13 February 2024

Our Ref: P223_248-3 (BCA & ACCESS) JR

KNOX GRAMMAR SCHOOL: EWAN HOUSE
BCA CAPABILITY STATEMENT

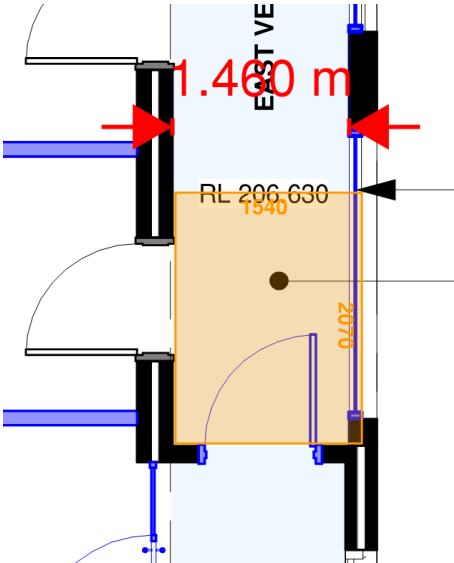
DESCRIPTION / PROPOSED STANDARD OF PERFORMANCE	STATUTORY REQUIREMENT	COMMENT
		 Figure 4.0 – Timber flooring in the accessible path of travel to be further investigated as the project progresses <u>TGSI's (Clause 9)</u> Tactile ground surface indicators have not been documented in the design; however, it is capable of achieving compliance with this clause. As the design progresses beyond DA, the following may be pursued: ▪ updated design detail shall be provided which confirms compliance with clause 9 of AS1428.1-2009; or ▪ Alternatively, a performance solution may be pursued to remove TGSIs from the proposed ramps and stairways. <u>Ramps (Clause 10.3)</u> The proposed 1in14 ramp is capable of achieving compliance with this clause. As the design progresses beyond DA, further ramp detail shall be provided which confirms compliance with clause 11 of AS1428.1-2009. <u>Stairway (Clause 11)</u> The proposed two (2) external stairways are capable of achieving compliance with this clause. As the design progresses beyond DA, further design detail shall be provided which confirms compliance with clause 11 of AS1428.1-2009. DC Comment – It has been identified that the handrail serving the stairway protrudes into the traversable

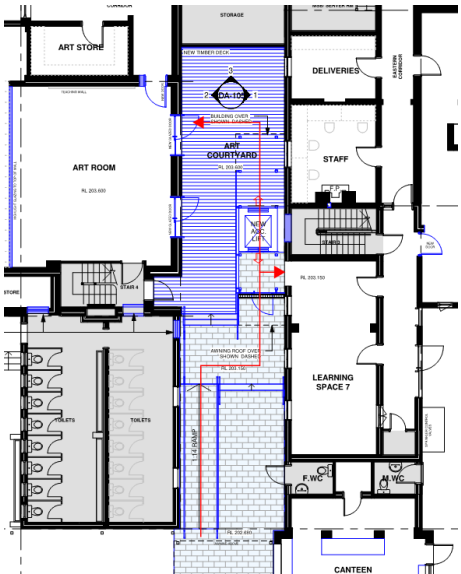
DESCRIPTION / PROPOSED STANDARD OF PERFORMANCE	STATUTORY REQUIREMENT	COMMENT
		accessible path of travel, thereby creating a non-compliance. As such the following design resolutions are recommended: ▪ Option 1 – Introduce a blade wall / plinth behind the handrail to create a barrier; or ▪ Option 2 - Pursue a performance solution to remove the secondary handrail with reliance on 'lift' access as the primary accessway to the building  Figure 4.1 – Handrail obstructing the accessible path of travel <u>Handrails (Clause 11&12)</u> As the design progresses beyond DA, further design detail shall be provided which confirms compliance with clause 11 and 12 of AS1428.1-2009.
